RTL8111E/RTL8105E 48Pin Reference Schematic V102

RTL8111E/8105E Reference circuit: Change Notes

Title
RTL81111E/8105E Reference circuit: Power

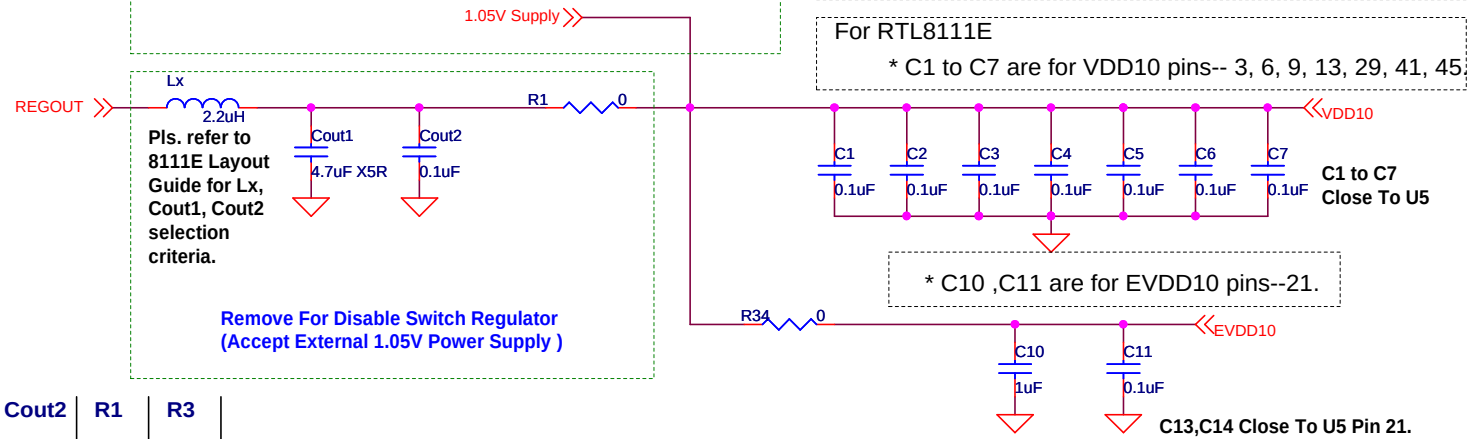
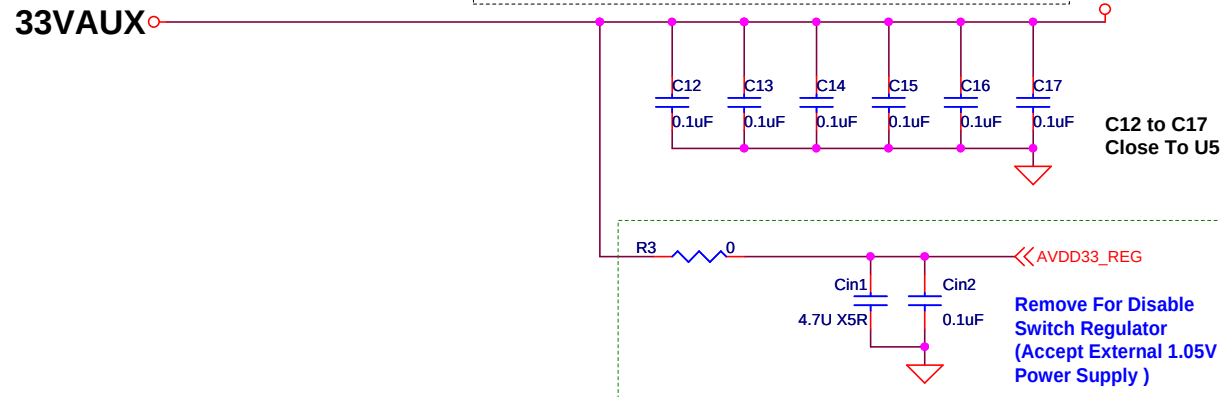
1. C17 rename to Cin1, C18 rename to Cin2. C8 rename to Cout1, C9 rename to Cout2, L1 rename to Lx to align with SWR Layout guide (Page 2)
2. Add supported resistor values for Dual Color LED , supported combinations when using EEPROM (Page 3)
3. Add R38 for external clock circuit. (Page 3)

1. Update Pin3 , Pin47 For RTL8105E.(Page 3.)
2. Update Bypass Capacitor Description For RTL8105E and RTL8111E. (Page 2.)
3. Modify Center tap Schematic for Power Optimization.(Page 3.)
4. Add RTL8105 Optional Function Schematic.(Page 4.)
